**CITY OF VANCOUVER
PLANNING & DEVELOPMENT SERVICES**

**DEVELOPMENT PERMIT STAFF COMMITTEE
MEETING
January 22, 2020**

**150 Robson Street (COMPLETE APPLICATION)
DP-2019-00809 – CD-1 (Pending)**

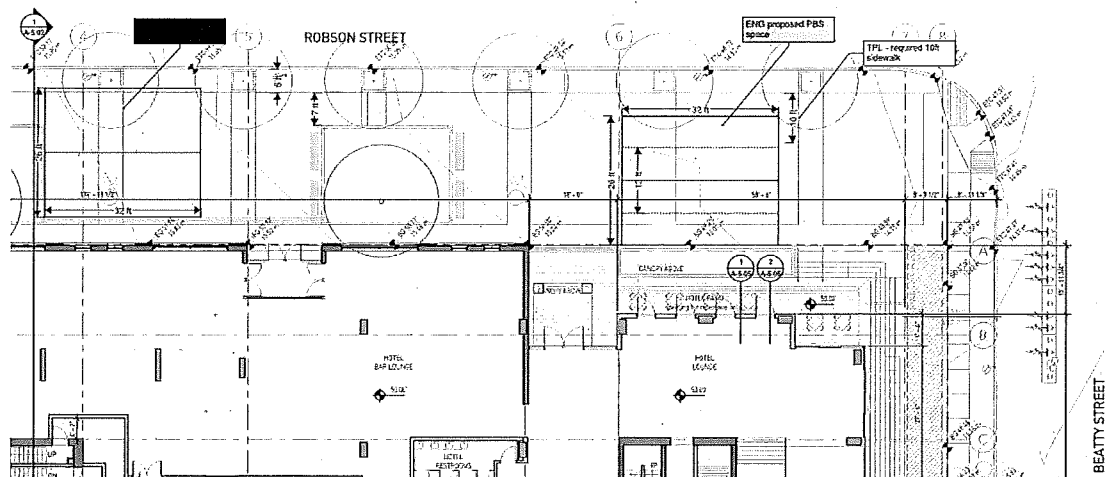
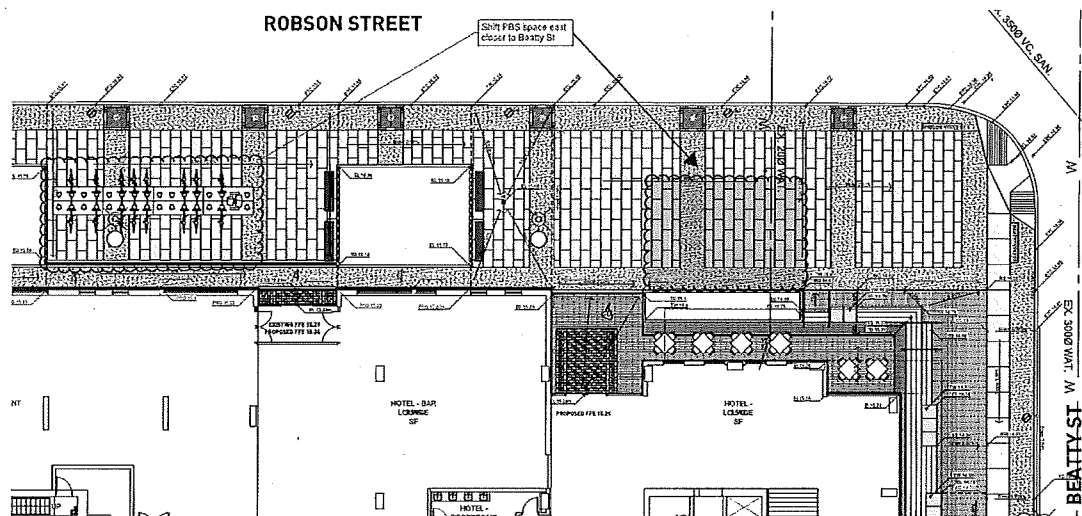
- A.2.12 provision of updated drawings to show uninterrupted space on public property along the Robson Street sidewalk to accommodate a 19 m x 4 m (linear) or 10 m x 8 m (back-to-back) PBS station.

Note to Applicant: The PBS space as shown on Drawing A1.07 on public property mid-block along Robson St is not acceptable. This proposed location does not provide for easy access to the street. Applicant to revisit shifting the PBS space closer to Beatty St. – see sketches below for reference.
